Access Compliance Report

Public Rights-of-Way

(Curb Ramps)

Intersection ID: 44025	Main Street: EASTWAY_DR	Cross Street: EASTWAY_DR_RA	Location: NE
ADA ID: A53FF968AB3B	Ramp Type: Perp	Initial Pass/Fail: Fail	Overall Compliance: No
Severity Score: 60			
Codes/Mitigation Info/Possible Solution		Field Measurements/Component Compliance

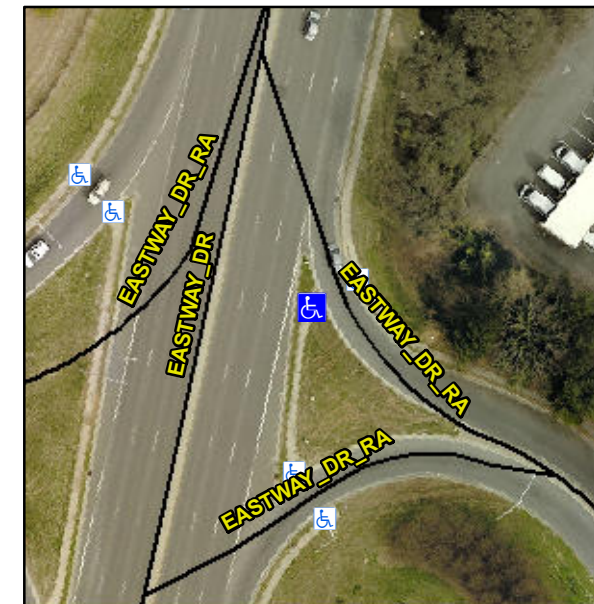
Not Found, R304.5.1, R304.2.2, R304.5.3

Compliance	Description	Data	Compliance	Description	Data
N/A	Ramp Length (in)	74.5	No	Ramp Slope (%)	9.1
No	Ramp Width (in)	31.0	No	Ramp XSlope (%)	5.3
N/A	Flare Type LT	N/A	N/A	Flare Type RT	N/A
N/A	Flare Slope LT (%)	N/A	N/A	Flare Slope RT (%)	N/A
N/A	Flare Traversable LT?	N/A	N/A	Flare Traversable RT?	N/A
N/A	Landing Length (in)	N/A	N/A	DWS Provided?	N/A
N/A	Landing Width (in)	N/A	N/A	DWS Contrast?	N/A
N/A	Landing Slope (%)	N/A	N/A	DWS Length (in)	N/A
N/A	Landing X Slope (%)	N/A	N/A	DWS Full Width?	N/A
N/A	Landing Curb? (Y/N)	N/A	N/A	DWS Offset (in)	N/A
N/A	Shared Landing?	N/A			
N/A	Gutter Ponding?	N/A	N/A	Gutter Slope (%)	N/A
N/A	Gutter Lip Ht (in)	N/A	N/A	Gutter X Slope (%)	N/A
N/A	Painted X Walk1?	No	N/A	Painted X Walk2?	N/A
	X Walk 1 Direction	To N		X Walk 2 Direction	N/A
N/A	X Walk 1 Width (in)	N/A	N/A	X Walk 2 Width (in)	N/A
	X Walk 1 Slope (%)	5.5		X Walk 2 Slope (%)	N/A
	X Walk 1 X Slope (%)	4.4		X Walk 2 X Slope (%)	N/A

Remove & Replace Entire Ramp.
